Agenda Item No. (3)

Subject: **AUTHORIZE APPROVAL OF CONTRACT CHANGE ORDER NO. 09 TO
CONTRACT NO. 2025-B-052, GOLDEN GATE SUSPENSION BRIDGE
SEISMIC RETROFIT, CONTRACT 1 – NORTH AND SOUTH TOWERS AND
NORTH AND SOUTH SIDE SPANS, WITH HALMAR INTERNATIONAL,
LLC**

Figure 2 – Floorbeam Painted by Bridge Paint Department in Span 4

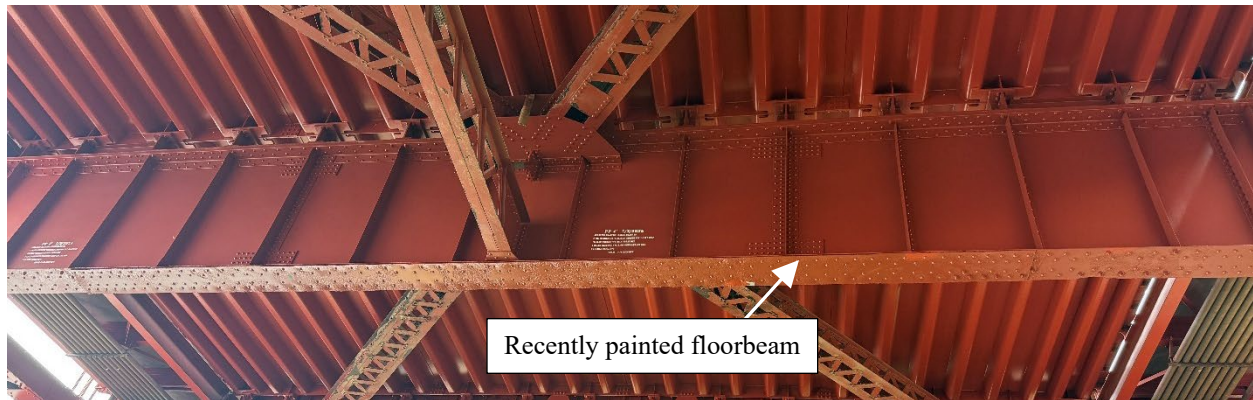
During the preconstruction phase of Contract No. 2025-B-052 when the scope of work was being developed, the Golden Gate Bridge, Highway and Transportation District's (District) Bridge Paint Department was involved with a project cleaning and painting various elements at the North Side Span, including some of the floorbeams. Engineering staff evaluated the floorbeam clean and paint production being performed by the District's forces, estimated how many floorbeams would be completed prior to the commencement of the Contract No. 2025-B-052 work, and then modified the Contract No. 2025-B-052 floorbeam clean and paint scope of work to eliminate those floorbeams in the North Side Span that were to be cleaned and painted by the District's Bridge Paint Department. In particular, Contract No. 2025-B-052, specifies that blasting and cleaning of thirteen floorbeams in the North Side Span was not required, except for areas requiring surface preparation and painting due to the attachment of other elements that connect to the floorbeams as a part of the retrofit.

The District's Bridge Paint Department continued with the painting operations at the North Side Span through the time of award of Contract No. 2025-B-052. However, in order to complete the demobilization of all equipment and access platforms from the North Side Span and clean up the areas that are specified for the Contract No. 2025-B-052 Contractor's use as staging areas, the District's Bridge Paint Department was not able to complete the cleaning and painting of all surfaces of the floorbeams. The eastern 13-foot portions of certain floorbeams were not blast cleaned and painted.

It is necessary to blast clean and paint the entire surface of each floorbeam to ensure the structural integrity, and preserve the life span, of each floorbeam element. Engineer staff informed the Contractor of the additional scope of work and the parties reached an agreement to have the additional 1,600 square feet (sq. ft.) of floorbeam surfaces cleaned and painted at the Contract Bid Item unit price of \$214.76 per sq. ft., for a total agreed lump sum amount of \$343,616.00.
